**STAFF REPORT
Planning**

Title: Zoning By-law Amendment Z-21-12, 535 Quiet Place, Hickory Terraces Limited
Report Number: IPPW2022-010
Author: Max Kerrigan
Council Date: February 14, 2022
File: Z-21-12
Attachments: Appendix A – Minutes of Informal Public Meeting
Appendix B – Agency and Staff Comments
Appendix C – Site Plan
Appendix D – Building Perspective
Appendix E – Conceptual Building Cross-Sections
Map 1 – Subject Site
Map 2 - Zoning By-law Amendment Z-21-12

Figure 2: Parking within Front Yard

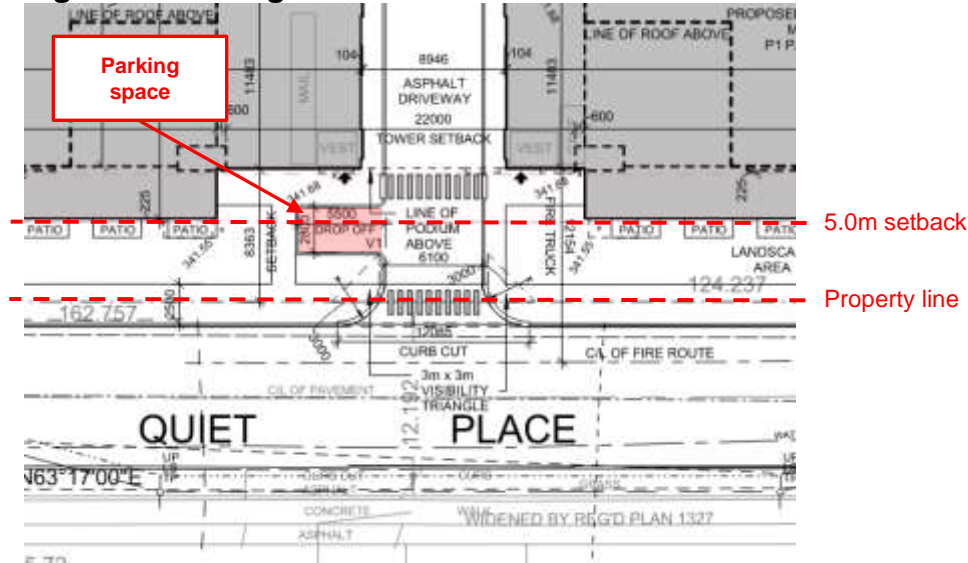
The Applicant is requesting relief from Regulation 6.1.6.2 in ZB2018-050 to permit one parking space within the Front Yard between the Front Building Line and the Quiet

Place right-of-way to accommodate couriers / parcel delivery, food delivery, pick-up/drop-off, etc. on the property. The parking space encroaches into the front yard building line by 1.89m.

Staff do not object to the Applicant’s request to permit one (1) parking space within the Front Yard Building Line, to provide a dedicated short-term parking space for couriers / parcel delivery and pick-up/drop-off. The proposed parking space will reduce the likelihood of such vehicles occupying the Quiet Place right-of-way or blocking the vehicular entrance to the parking area behind the building face. Substantial landscaping will be required to soften the appearance of the parking space in the front yard, which will be secured through the Site Plan process.

2029 Modelling Scenario

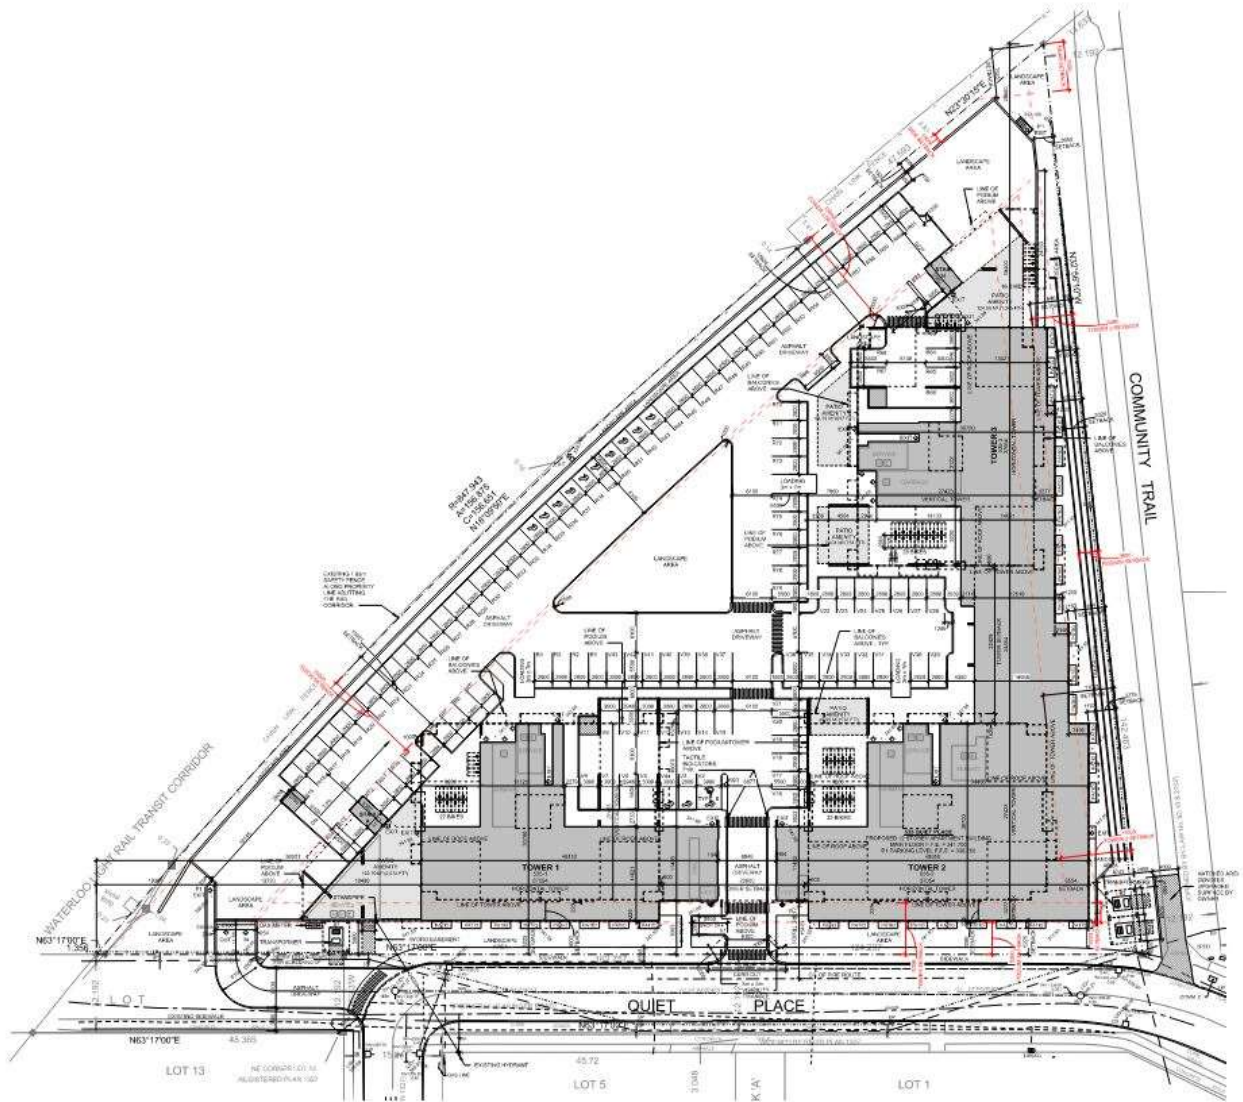
1. The proposed flow of 10.5 L/s was accounted for in MH C6-5 flows, as noted in the Report. The 2029 projected 'post-development' modelling results indicate that the sanitary sewer on Albert Street immediately downstream of the proposed development appears to have available capacity under wet weather modelling scenarios, reaching a depth of 75% full, as shown on the figure below. The model

indicates that the sewer system further downstream on Albert Street appears to be at capacity for the projected 2029 flows (but not surcharging). This system will be analyzed in greater detail in the upcoming 2021/2022 Sanitary Master Plan update along with all apparently at-capacity sewers in the City.
